PlanGrid Task Report - Jan 29, 2025

#41 [SITE 500] [NEW] TAB is complete.

L05075_Cedarbrook Plaza (Wyncote, PA) FSU

#39 [UNIT 999] [NEW] (MISC) AC4 FroStat Tripped Alarm

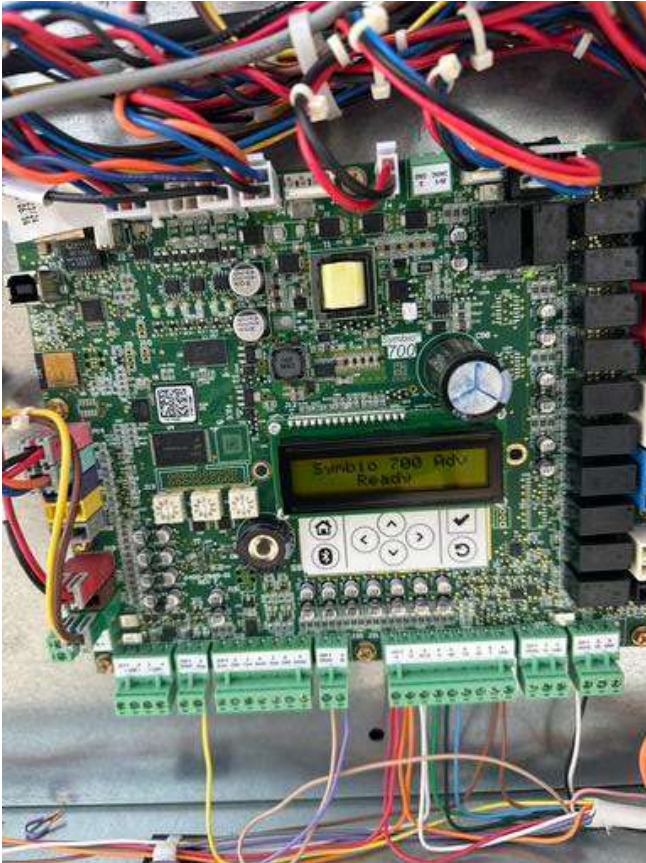
AC4 has an active alarm "FROSTAT TRIP" and it is preventing the condensers from turning on during cooling. Tech tried to put unit into test cooling and while fan speed increase, the condensers did not turn on.

Provide picture of TRANE display screen with no alarms to close. Attached picture is of incorrect display/unit.

IMG_4132
Jacob Davidson
Nov 21, 2024 1:12 PM

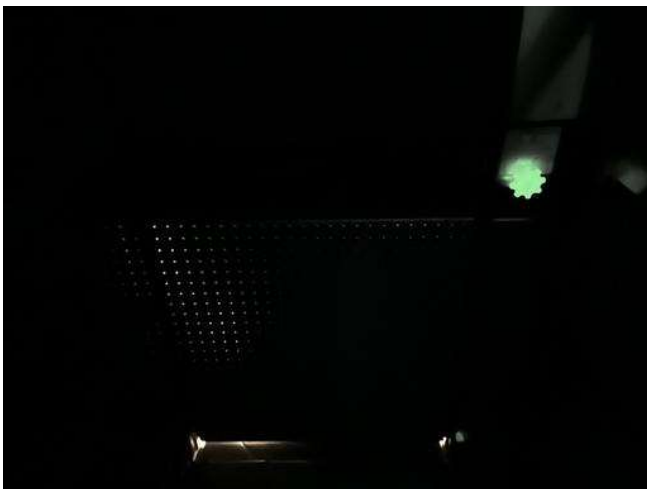
WIC door sweep is not sealed tightly with threshold when door is closed. Only translucent light should be present inspecting from the inside out with box lights off.

Cooler tech lowered the door down as far as it will go but there are gaps in the tile where light can still be seen. To alleviate this, a threshold will need to be added.

M-701

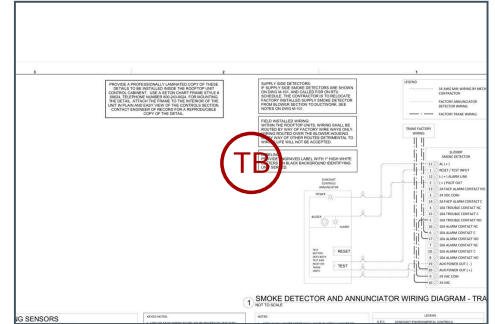
Label all sensors, humidistats, thermostats, smoke annunciators and remote space mounted OADs, MODs, VFD's for which piece of equipment they serve. Most are labeled but some are not.

Labels not worded per plan. Recommend replacing or seeking approval as-is from CFA CM.
